REFERENCE:	Nova Bus Manuals
SECTION:	09 Engine Cooling
RS N°:	7621-418
EFFECTIVE IN PROD.:	L690 (2012-04)

APPLICATION DEADLINE: 2015AL30  
CLAIM REFERENCE NUMBER: WB-3126

SUBJECT:	Leaking at the engine auxiliary heating outlet hose.
JUSTIFICATION:	Outlet hose may crack because the heat shield become detached and do not protect against heat.

*Figure 3 - Heat Shield With Staples*

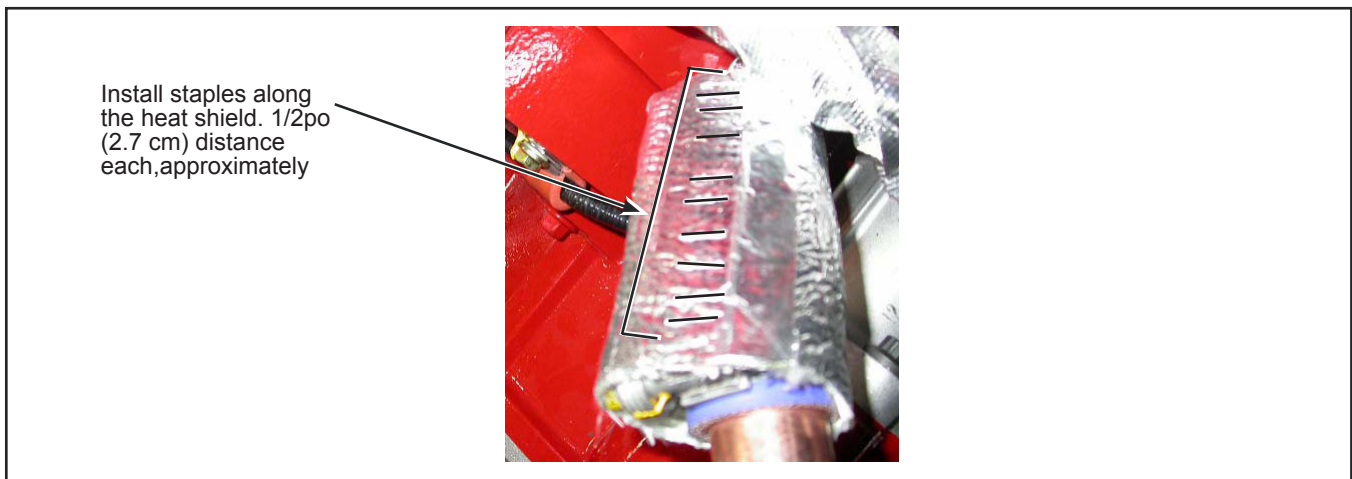
- 1.3. Remove and retain the heat shield.
- 1.4. Visually verify the physical appearance of the hose.
- 1.5. If the hose is cracked, proceed to Level 2 of this document.
- 1.6. If the hose is not cracked:
  - 1.6.1. Install the retained heat shield, or new N49339 heat shield if the original heat shield is damaged.
  - 1.6.2. Staple the heat shield. See Figure 3. Staple should be positioned underneath the hose. It is suggested to use a plier type stapler.

Figure 4 - Hose Clamps Torque

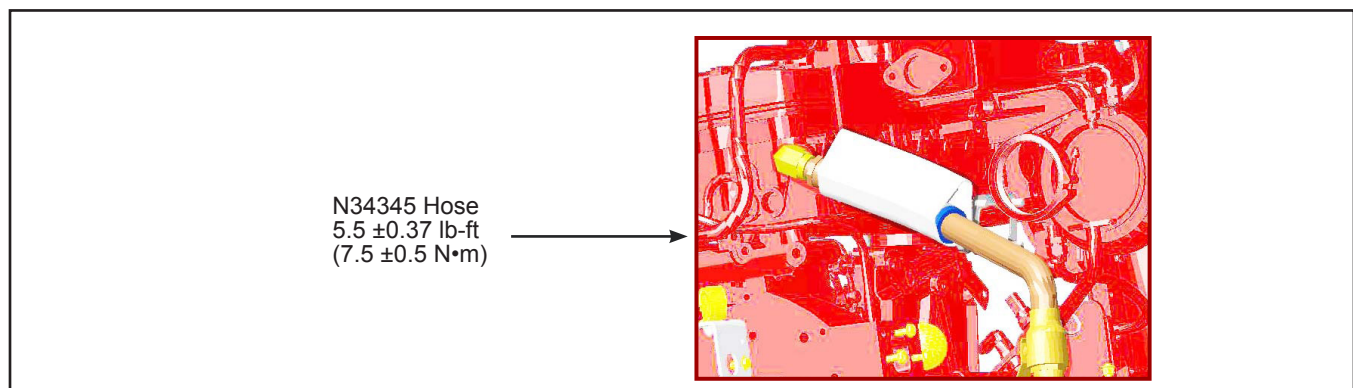
- 2.1. Drain the cooling system as described under the leading **DRAINING THE COOLING SYSTEM** in section 09-302: **ENGINE COOLING, T-DRIVE** in the Nova Bus maintenance manual. A drain pan to recover the coolant liquid is required.
- 2.2. Once draining is completed, remove the cracked hose. Retain the clamps.
- 2.3. Install the retained clamps on the new hose N34345.
- 2.4. Install the new flexible coolant hose N34345. Tighten the clamps to the torque indicated in Figure 4.
